Rezoning Transportation Analysis
Petition Number: Insert Zoning Petition #2020-181
General Location Identifier: 11122105

From: Brandon Brezeale, PE
Brandon.Brezeale@charlottenc.gov
704-432-5561

Reviewer: Walta Blackmon
Walta.Brumskine@charlottenc.gov
704-432-1556

Date	Description
01-21-21	First Review (WB)
02-15-21	Second Review (WB)
04-23-21	Third Review (WB)
05-27-21	Fourth Review (WB)
09-28-21	Fifth Review (BKB)
10-13-21	Sixth Review (BKB)
10-26-21	Seventh Review (WB)

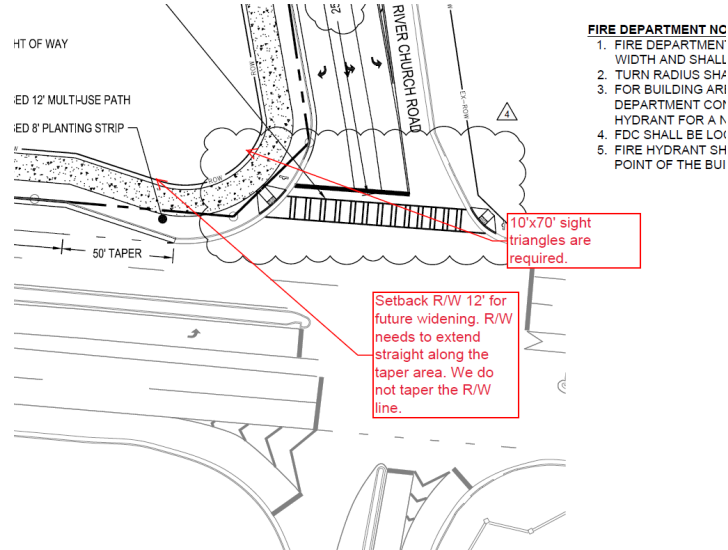
1. ~~**Curblines:** The proposed zoning district has a setback measured from back of the existing or proposed future curblines.~~
 - a. ~~**Albemarle Road:** The site plan reflects the future location of curb and gutter.~~

~~Label and dimension the curb and gutter from the centerline for each road on the site plan.~~
